APPLICATION NO.	FILING DATE	FIRST NAMED INVENTOR	ATTORNEY DOCKET NO.	CONFIRMATION NO.
10/772,101	02/04/2004	Jacques Seguin	CVALVE.006CPI	6184
20995 7590 02/14/2007 KNOBBE MARTENS OLSON & BEAR LLP 2040 MAIN STREET FOURTEENTH FLOOR IRVINE, CA 92614			EXAMINER SCHILLINGER, ANN M	
			ART UNIT	PAPER NUMBER
			3738	
SHORTENED STATUTORY PERIOD OF RESPONSE		NOTIFICATION DATE	DELIVERY MODE	
3 MONTHS		02/14/2007	ELECTRONIC

Office Action Summary

DETAILED ACTION

Attachment A

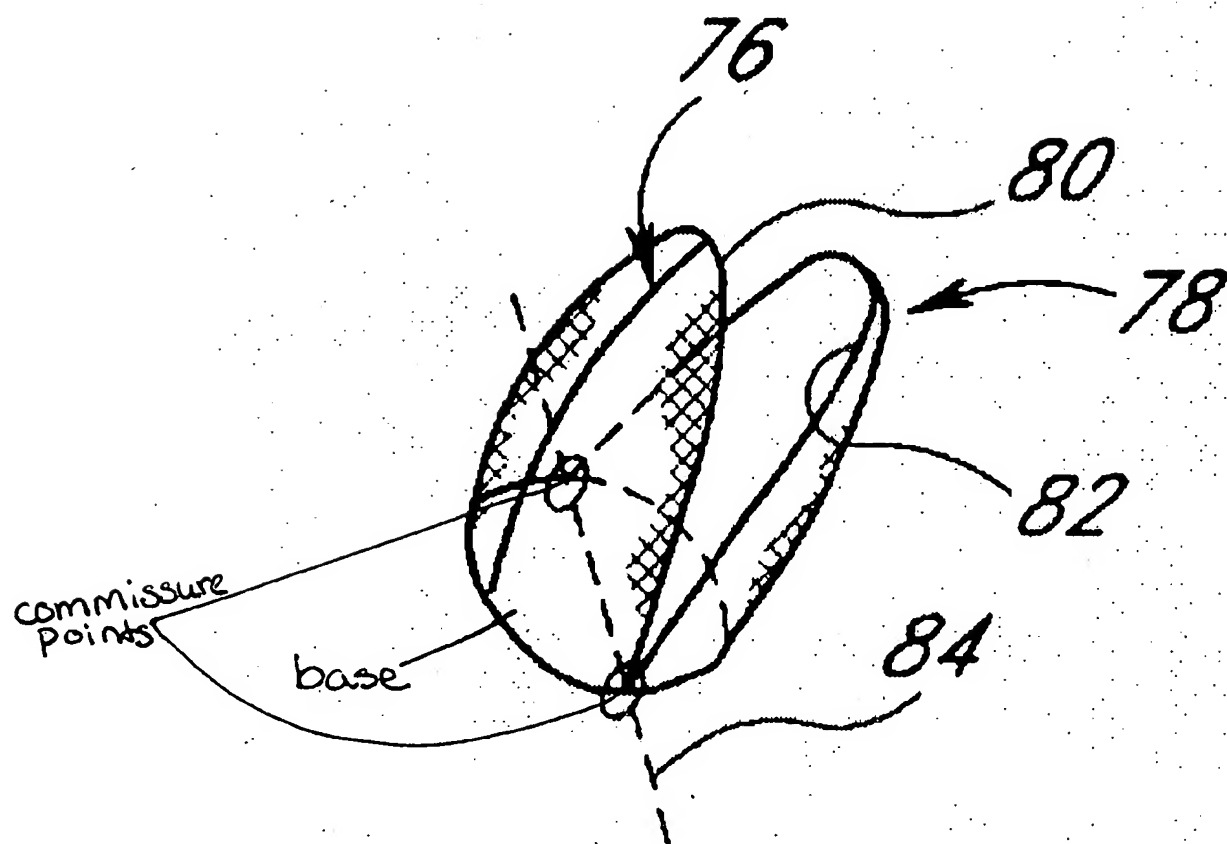
Claims 79-86, 88, 90-93, 96-104, and 110 are rejected under 35 U.S.C. 102(b) as being unpatentable over Shaolian et al. (US Patent No. 6,299,637). Shaolian et al. discloses the following of claim 79: a prosthetic valve assembly (40) for use in replacing a deficient native valve (30), the valve assembly comprising (col. 2, lines 55-58): a valve having a base (see

attachment A), a plurality of commissure points (see attachment A), and a plurality of resilient leaflets (76, 78); a valve support (44) configured to be collapsible for transluminal delivery (col. 5, lines 36-37) and comprising a single length of wire (col. 6, lines 63-64), a first portion (52) and a second portion (54), said first portion expandable to contact the anatomical annulus of the native valve (30) when the assembly is properly positioned, said second portion supporting the base and the commissure points of the valve (50 or 54); and a radial restraint for controlling a diameter of the second portion (col. 5, lines 36-41; Figures 1, 4, 6); wherein the single length of wire has a reduced thickness to decrease the radial expansion force (see Figure 1, and explanation applied to claim 16, above).
